NEWTOWN TO CITY  
TRANSITIONAL CYCLEWAY  
90% DETAILED DESIGN ROAD SAFETY AUDIT  
PREPARED FOR WELLINGTON CITY COUNCIL  
March 2022

## Newtown to City Transitional Cycleway 90% Detailed Design Road Safety Audit

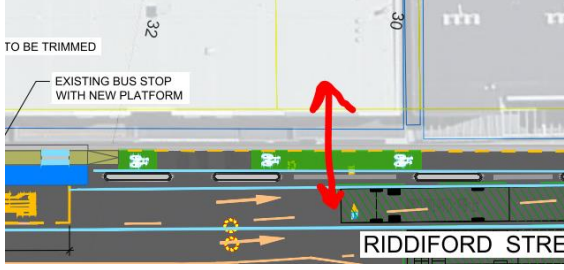
In reviewing the 90% Detailed design the SAT acknowledge that there has been an addition of green surfacing at conflict points, however, there remain locations where additional surface markings are required.

1. 32 Riddiford Street - off street parking accessway
2. Girton Tce – green dashed lines over intersection
3. Bus / cycle lane Riddiford Street right turn into Adelaide Road – dashed green line through on bus lane path to highlight special vehicle lane.

Frequency Crashes are likely to be occasional	Severity Death or serious injury is likely	Rating The safety concern is moderate
Designer response	<p>32 Riddiford Street access has green markings on drawings. No change proposed. Should be noted that Council have requested rationalisation of the green surfacing to high-risk locations only. This will be reflected in the 100% designs.</p> 	<p>Cycle lane does not start till after Girton Terrace, as the area where cyclists will be travelling is a bus lane rather than a cycle lane there are issues with placing cycle</p>

warning markings in a bus lane. Sharrow symbols could be marked at high risk locations. Do not think Girton Terrace meets this criteria – no change proposed.
	Do not see safety benefit from marking green dashed continuity line through intersection, proposed signage (to be included with 100% design) and other markings sufficiently convey allowed movements from the left lane on Riddiford Street. No change proposed.
Safety Engineer comment	Agree with Designer.
Client decision	Request from Cycle advocacy group for additional green dashed continuity line through intersection.
Action taken	Update plans to reflect the green dashed continuity lines through John Street, Adelaide, Riddiford Street.

Figure 2-1: Riddiford Street southbound bus stop

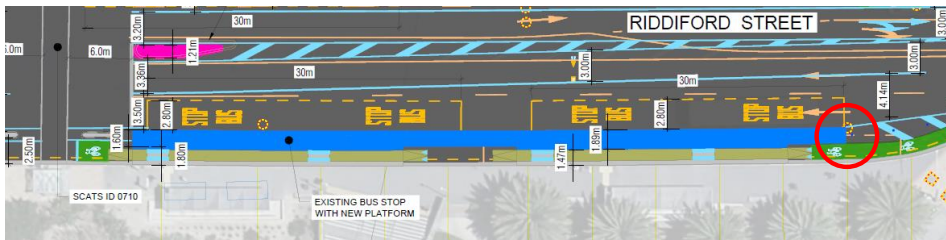
In reviewing the design, the SAT noted that the platforms are formed with square end raised ends (circled below). This will result in a vehicle / motorcyclist / cyclist snag point should an errant user impact with the end of the platform. For vehicles, the damage would be predominantly vehicle damage only, however for a motorcyclist and cyclist the injuries could be serious, with a resultant loss of control into the adjacent traffic lane and risk of impact from other traffic.

It is noted that the southbound lane leading into the bus stop is a general lane north of the hospital road intersection but is multiple bus stops following. This could cause late lane changes should a bus stop in the bus stop. It is acknowledged that as a general operation, buses will stop in traffic lanes to onboard / disembark passengers. Predominantly this occurs in the marked bus lane and should have little impact on the general user. In and around the hospital the stopping in the general traffic lane will have a greater impact.

Frequency Crashes are likely to be occasional	Severity Death or serious injury is likely	Rating The safety concern is moderate
Designer response	Markings guide vehicles to avoid end of platform – no change proposed.

Figure 2-3: Riddiford Street Bus Platform and adjacent cycle lane

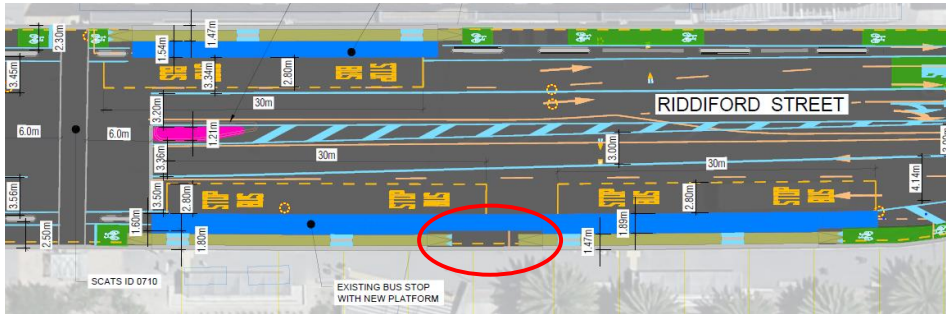
The drawings provided are considered indicative of the design intent and lack clarity of the treatments required for the full consideration of the bus stop use.

The SAT comment that the design includes pedestrian style crossings at multiple locations, assuming that these relate to the door positions of buses. The SAT comment that the bus will operate with both front and rear doors, therefore multiple crossing points will be required to accommodate the movement positions, not just front door. The design lacks clarity around the provision of TGS1 for the bus stops and movement positions over the cycle facility. Tactile and lead pavers are required for bus stops.

A feature of the Hospital bus stop is the formation of a ramp down / up midway between the two bus stop facilities (circled in Figure 2-3 above). This will result in a trip / fall hazard, and is considered a significant risk to the elderly, mobility impaired and visually impaired.

1. Install pedestrian crossing features for both the front and rear door positions for the bus patron movement over the cycle facility.
2. Install a red pavement surface at bus stops indicating the conflict zone between bus patrons and cyclists.
3. Develop a Signs & Markings drawing set prior to going to Tender. This drawing set should be reviewed to ensure that all required elements are incorporated into the design.
4. Apply a consistent bus stop treatment to ensure consistency over the greater Wellington cycle network.
5. Eliminate the set-down section between the two bus platforms

Frequency	Severity	Rating
Crashes are likely to be occasional	Death or <b>serious</b> injury is likely	The safety concern is moderate
Designer response	Council have purchased an off the shelf product which includes coloured components to highlight risk areas as shown below. It is acknowledged that conflicts

<p>will also exist at the rear bus doors, the intention of the red surface is to highlight the whole area is a potential conflict zone. The intention of the proposed layout shown below is to try and be as consistent as possible with previous treatments around Wellington city including Victoria Street around Kilbirnie e.g. Crawford Road.</p> <p>The 100% designs will include a signs and marking drawing. Signage for cyclists at bus stop conflicts will be provided where passengers will be alighting directly into the cycle path (not relevant for this section).</p> 
	<p>Risk of ramp down / up midway between the two bus stops noted but disagree that the risk is significant. The likelihood of a crash should be low given most patrons will walk directly from the bus to the footpath – not along the platform. The additional ramp will help slow cycle speeds which supports the SAT's concerns about 'cyclists impacting with the elderly while the elderly were alighting from the bus'. No change to ramp proposed.</p>

Figure 2-5: Riddiford St / Adelaide Road / Johns Street

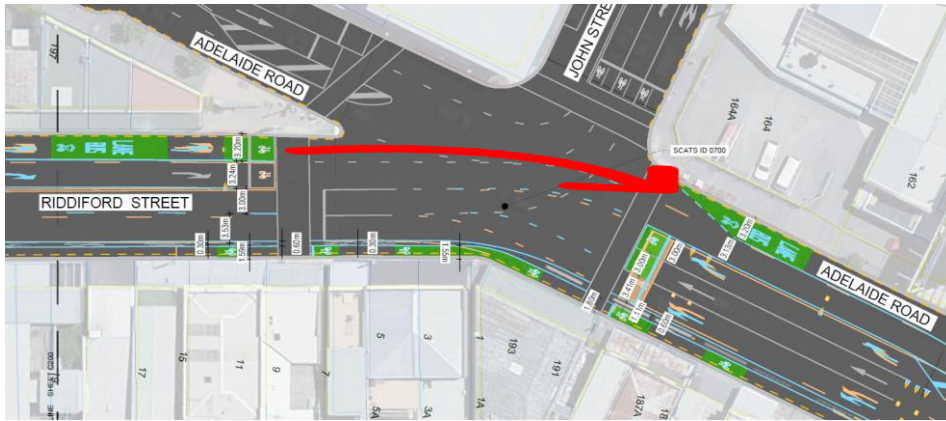
The bus / cycle lane is marked in accordance with the two user classes; however, the lane markings (left turn arrow) would prohibit a through movement of both a bus and a cyclist unless an exemption is enabled. This has not been detailed.

Frequency Crashes are likely to be common	Severity Death or serious injury is likely	Rating The safety concern is significant
Designer response	As noted in response to 2.1.1 proposed signage (to be included with 100% design) and other markings sufficiently convey allowed movements from the left lane on Riddiford Street. No change proposed.	
Safety Engineer comment	Agree with SAT – signal information should be provided.  Key signalised intersections to be reviewed in <i>Safety in Design Workshops</i> .	
Client decision	Road markings updated to include green continuity lines across intersection. Safety in design workshop for signals.	
Action taken	Safety in design workshop for signals. Plans updated.

Figure 2-9: Lane widths on Adelaide Road and width of separators

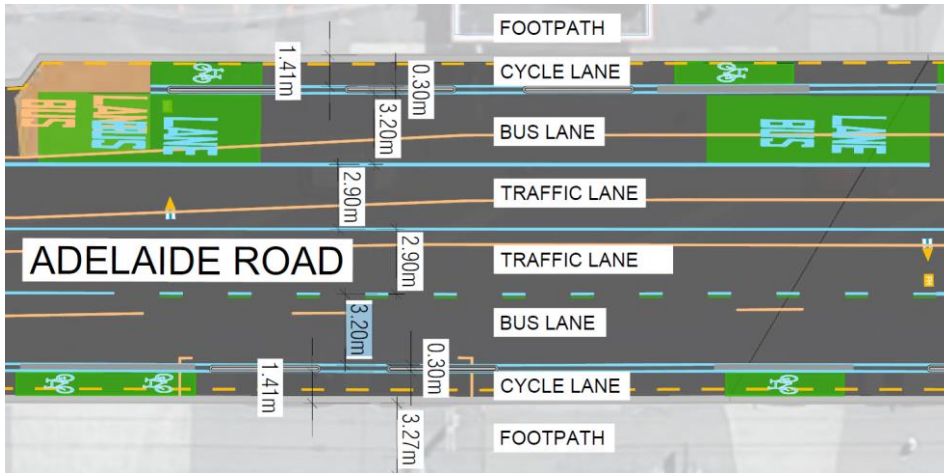
The road layout dimensions indicate that the physical separator is some 300 mm wide, with a 1.4 metre cycle facility alongside.

The SAT question the viability of a physical separator, especially of a temporary design for this width. It is acknowledged that some "stick-on" type separators closely match this width but would generally eliminate the capacity to install the detailed linework. The preferred separator should be of a size that deters people from driving over them.

1. Detail the specific separator type, and characteristics to ensure that sufficient deterrence is provided alongside the facility.

Frequency Crashes are likely to be occasional	Severity Death or <b>serious</b> injury is likely	Rating The safety concern is moderate
Designer response	Not a concern has physical separators are proposed.	
Safety Engineer comment	It is expected that the physical separators selected are fit for purpose and will deter vehicles driving over them.	
	Performance will be monitored and modified if necessary.	
Client decision	Agree with above	
Action taken	No action required

Figure 2-10: Bus stop south of Broomhedge Street

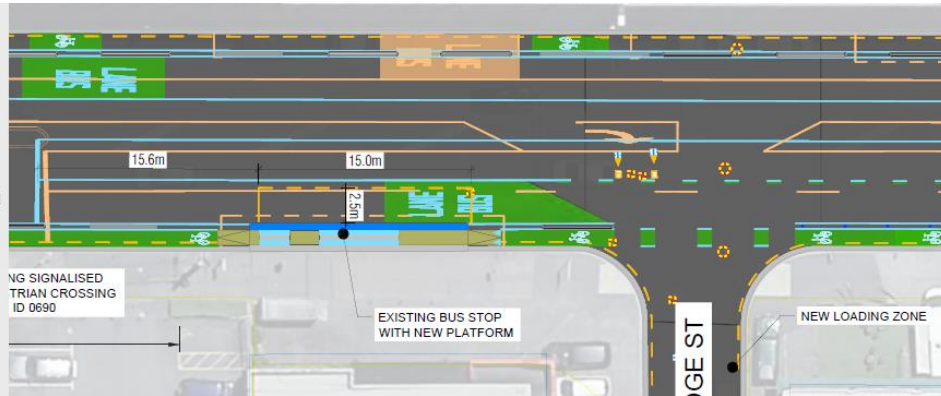
The narrow landing space would result in a passenger stepping from the bus directly into the path of a cyclists, with a risk of being clipped by passing cyclists.

1. Undertake a review of the bus platform design for the bus stops located at 101 and 110 Adelaide Road to provide a safe and appropriate landing zone for passengers alighting from the bus.
2. Provide a signs and markings drawing set for the controls required for cycle movement over the pedestrian facilities at bus stops
3. Install red pavement surface to all conflict zones as detailed in Section 2.1.2
4. Implement additional warning treatments into the design to assist Blind Low Vision users at these bus stops

Frequency	Severity	Rating
Crashes are likely to be occasional	Death or <b>serious</b> injury is very likely	The safety concern is significant
Designer response	<p>Council have purchased an off the shelf product which includes coloured components to highlight risk areas as shown below. The intention of the proposed layout shown below is to try and be as consistent as possible with previous treatments around Wellington city including Victoria Street.</p> <p>The 100% designs will include a signs and marking drawing. Signage for cyclists at bus stop conflicts will be provided where passengers will be alighting directly into the cycle path as per below.</p>

Safety Engineer comment	<p>Agree with Designer.</p> <p>The bus platform/cycle product and layout must be monitored and modified if necessary.</p>
Client decision	<p>Agree with above</p>
Action taken	<p>No action required</p>

Figure 2-11: Adelaide Road between Alfred St and Girton Tce – parking with adjacent bus lane

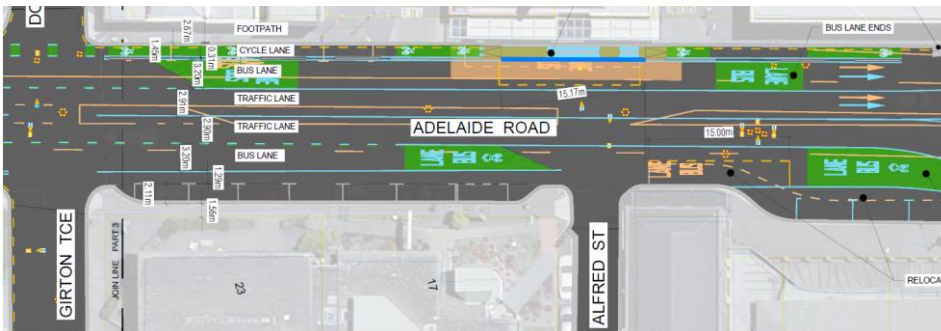
The design proposed has kerbside parking alongside the road shoulder between Alfred Street and Girton Terrace. Alongside this is an unmarked buffer, then the bus lane, as shown in Figure 2-11 below.

The supplied design drawings indicate that there are no side road control markings to define the hold point for Girton Tce. A review of previous site photos, and the aerial plans indicate that there is a current Give Way control. The SAT have assumed that the lack of side road control details is a draughting error, and that the current control will remain.

Frequency Crashes are likely to be occasional	Severity Death or <b>serious</b> injury is very likely	Rating The safety concern is significant
Designer response	Agree – drawings should reflect current give-way controls remain. Dashed green markings concern previously identified in section 2.1.1 – refer previous response.	
Safety Engineer comment	Agree with Designer.	
Client decision	Agree with above	
Action taken	No action required

Figure 2-12: Adelaide Road / Rugby Street Intersection

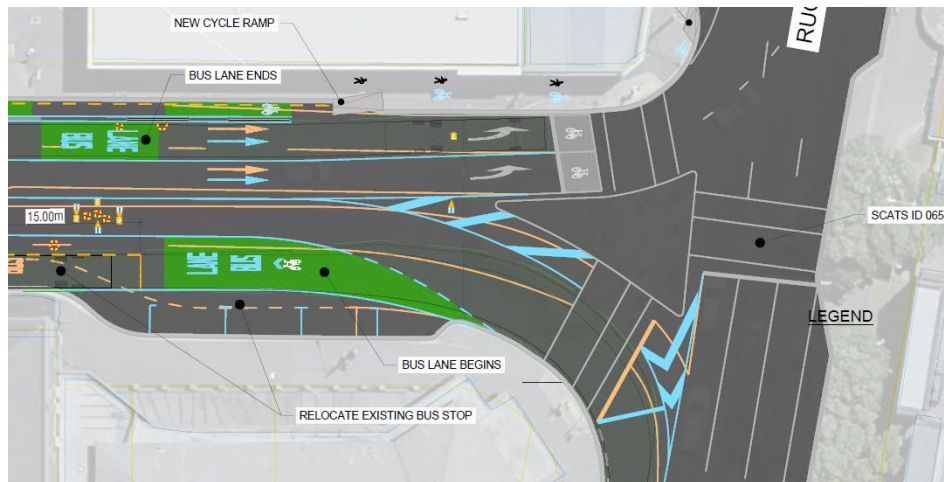
The tracking path for the bus has been supplied and demonstrates that the bus left turn can be accommodated within the provided lane. The SAT commend the solution provided.

1. There are no details to the configuration of the central splitter island. The SAT have assumed that there is no change to this arrangement. The SAT comment that the improved cycle facility along this route may result in the general increase in number of cyclists, resulting in a congested wait area.

5. A flush median is shown on the plans at the location of the splitter island. The SAT comment that this could be supported through the use of vertical bollards to reinforce the slow nature of the turn, provide additional stack space and shorten the crossing distance. This further reduces the risk of a driver undertaking a late turn / passing movement using the flush median.

Frequency Crashes are likely to be occasional	Severity Death or serious injury is likely	Rating The safety concern is moderate
Designer response	No change to function central splitter island – no change proposed. Agree that as demand increases the current facilities may become congested this should be considered as part of permanent changes along this corridor.  Agree with SAT.  Agree with SAT – vertical delineators should be included in the flush median!	
Safety Engineer comment	Agree with SAT and Designer.	
Client decision	Agree with above	
Action taken	Update designs to include additional vertical bollards around median.

Figure 2-13: Cambridge Terrace southern end of cycle lanes.

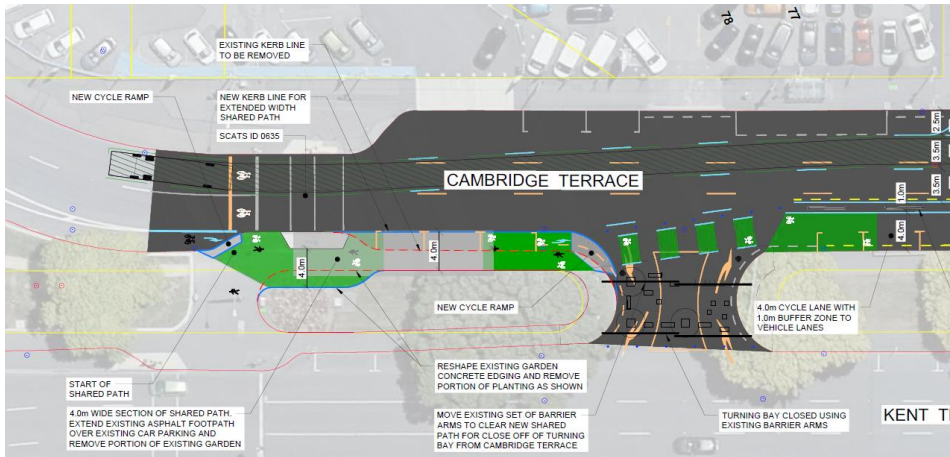
The SAT note that for the southbound movement (towards Basin Reserve), there is no guidance into a suitable facility, which could lead to cyclists in conflict with other footpath users either on the central path, or on the footpath on the Kent Terrace side.

The impact of a cyclist with vulnerable users such as the elderly and blind low vision people could result in higher severity injuries. As detailed, the elderly generally has a lower capacity to recover from high trauma injuries, with the resulting injury severity being serious.

Frequency Crashes are likely to be occasional	Severity Death or serious injury is likely	Rating The safety concern is moderate
Designer response	Agree with SAT	
Safety Engineer comment	Agree with SAT.  Detail on cycle lane continuity through or around the Basin has not been provided.  Although there have been general discussions on way-finding through the Basin, or around the Basin during an event, the absence of acceptable plans and detail continue to pose a moderate to significant risk. These should be included in the final package for overall approval of this cycleway.	
Client decision	Agree with above	
Action taken	No action required

Figure 2-14: Typical U-Turn closure detail

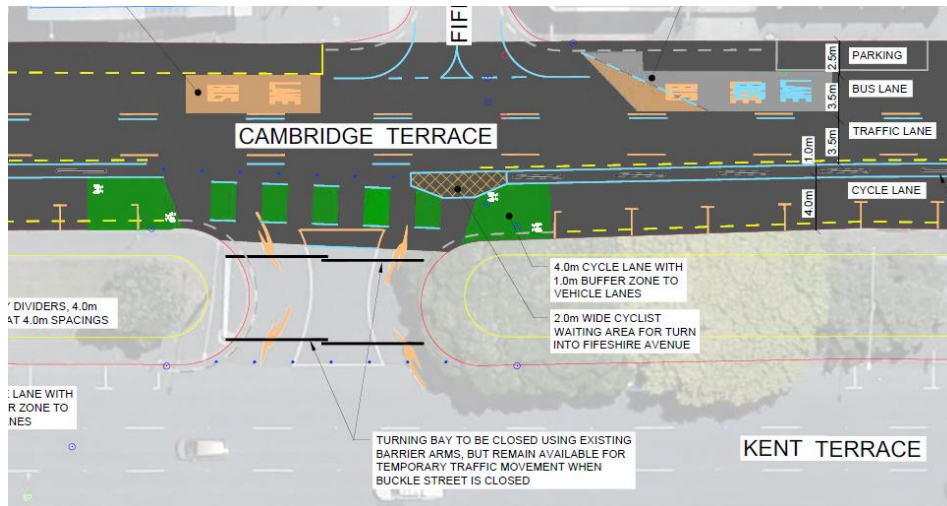
The use of vertical bollards will initially be effective due to their clean and new visible nature, however over time they will typically degrade and become ineffective. The vehicle movement alongside the bollards will result in wheel splash and covering in road grime. The SAT comment that a high level of maintenance intervention will be required to ensure that the bollards are fit for purpose and remain effective.

1. The design does not detail the effects on the greater network with the closure of the U-Turn pockets in place. The SAT comment that the removal of all U-Turn pockets south of Elizabeth Street may result in adverse turn movements at Vivian Street. The SAT recognise that the closure of the U-Turn pockets will require drivers to traverse around the Basin Reserve or Elizabeth Street to access business / streets on the opposite side of the central median.

1. That ROAD CLOSED / NO ENTRY / NO RIGHT TURN signs are installed on both sides of the central median, highlighting to drivers that the facility is closed.
2. That the bollards on the Kent Tce side are positioned such that safe pedestrian movement via kerb ramps is maintained when crossing over the U-Turn pocket.
3. That a high level of maintenance intervention of the closure bollards is applied on both a reactive and proactive manner.
4. That full retro-reflective material is applied to the barrier arms.
5. A detailed traffic management plan is developed early, that includes all actions, equipment and guidance required to address the change in priority for the U-Turn pocket.

Frequency Crashes are likely to be occasional	Severity Death or serious injury is likely	Rating The safety concern is moderate
Designer response	Agree with SAT – noting that some of these recommendations are already included in the design (e.g. item #2)/ and or currently exist (e.g. item #4).	
Safety Engineer comment	Agree with SAT and Designer.	
Client decision	Agree with above	
Action taken	No action required

Figure 2-15: Cambridge Tce and Fifeshire Ave intersection

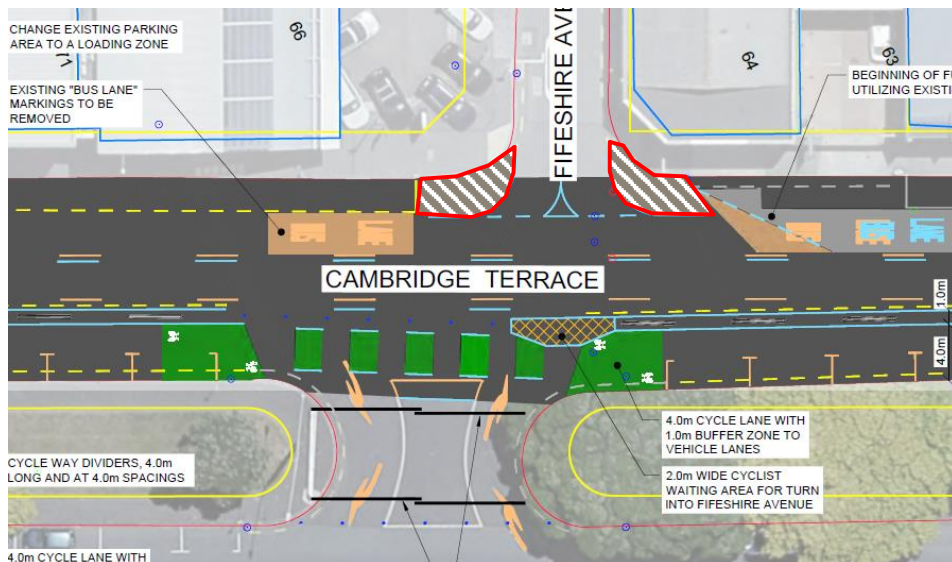
The SAT however do note that the design provides edge lines that commence on the traffic lane side of the loading zone, and turn into Fifeshire Ave, both sides. The current markings could be identified as a parking area. The SAT recommend that shoulder chevrons and no-stopping lines are installed to maintain the intervisibility sight line at the intersection (marked on Figure 2-15 above).

The revised design as presented in the 90% design drawings indicates that the kerb line (southbound, west side) has been adjusted to enable the passing of the bi-directional facility past the hook turn for Fifeshire Ave. The design fails to detail the provisions for pedestrians along the north / south route. The SAT note that with the closure of the U-Turn facilities, the central median route could become more attractive for pedestrian movement north and south as it eliminates the need to cross minor side roads.

1. That shoulder chevrons and no-stopping lines are installed at the Fifeshire Ave intersection to maintain the intervisibility sight lines at the intersection.
2. Change the hatched zone for the turn into / out of Fifeshire Ave to a standard hook turn facility with all markings and signs associated for the expected movements.
3. Confirm that full pedestrian movement is maintained on the west side of the central median.

Frequency Crashes are likely to be common	Severity Death or serious injury is likely	Rating The safety concern is significant
Designer response	Existing no stopping lines remain – no change proposed.  This issue has been identified and alternate markings will be developed for 100% designs. Care will need to be taken to not mix the markings up with hook turn markings which are appropriate for a certain function at an intersection.  Pedestrian movement will be able to occur, although the closed barrier arms may partially restrict desire lines. No drop-kerbs are currently provided for this pedestrian movement. This has been identified as a potential future enhancement along the corridor.	
Safety Engineer comment	Agree with Designer.	
Client decision	Agree with above	
Action taken	No action required

Figure 2-16: Cambridge Tce / Vivian Street intersection

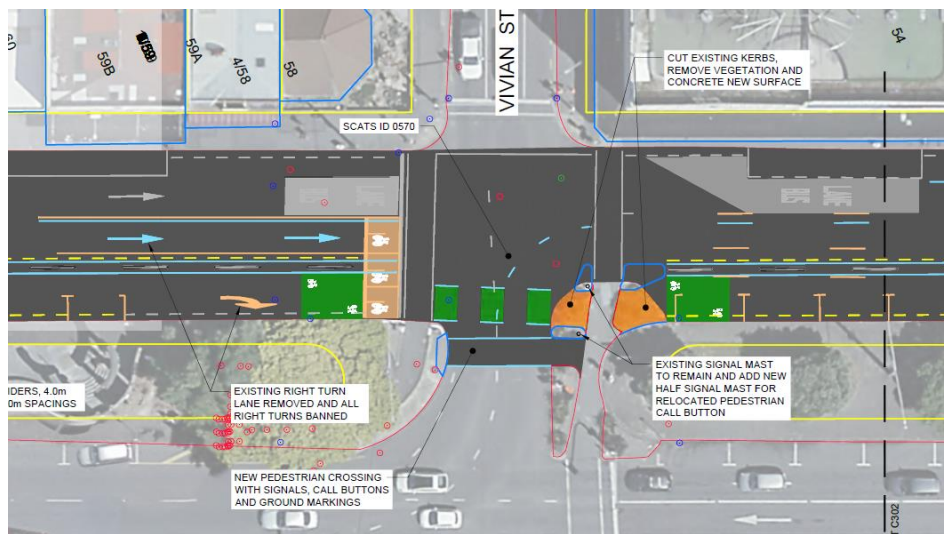
The cycle facility crosses over the pedestrian movement north of the Vivian Street intersection. This crossing does not indicate who has priority – pedestrian or cyclists. The pedestrian will be waiting at the edge of the crossing on the Cambridge Tce side, and depending on user and numbers, would result in pedestrians straying across the cycle path. The SAT recommend that pedestrian crossing bars, with all signs and markings being installed. This crossing requires tactile pavers for the pedestrian movement over the cycle facility.

The SAT consider that given the risk of the pedestrian / cycle conflicts, it is imperative that red pavement markings are installed at the conflict zone.

Frequency Crashes are likely to be common	Severity Death or serious injury is likely	Rating The safety concern is significant
Designer response	Agree with SAT – signal information should be provided.	
Safety Engineer comment	Agree with SAT – items 2-4 – additional information to be included in 100% designs.	
	Agree with SAT and Designer.	
	Key signalised intersections to be reviewed in <i>Safety in Design Workshops</i> .

Figure 2-17: Cambridge Tce turning pockets for cyclists

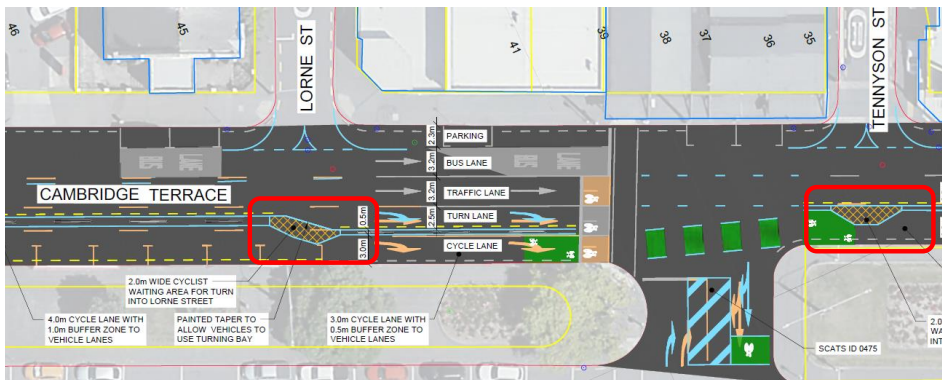
The hatched zone will be required to accommodate cyclists who not only turn in, but also turn out of Lorne Street and Tennyson Street. The SAT are of the opinion that the marked space is insufficient to allow cyclists to safely depart from the through movement, or wait safely to join the through movement, without their wheel being exposed to passing traffic. This waiting space impedes on the safe movement of cyclists along the bi-directional facility. The SAT acknowledge that the cycle turn volume at these locations may be low, however the risk remains.

Designer response	As per response to 2.4.3 this issue has been identified and alternate markings will be developed for 100% designs. Care will need to be taken to not mix the markings up with hook turn markings which are appropriate for a certain function at an intersection.
Safety Engineer comment	Agree with Designer.
Client decision	Agree with above
Action taken	No action required
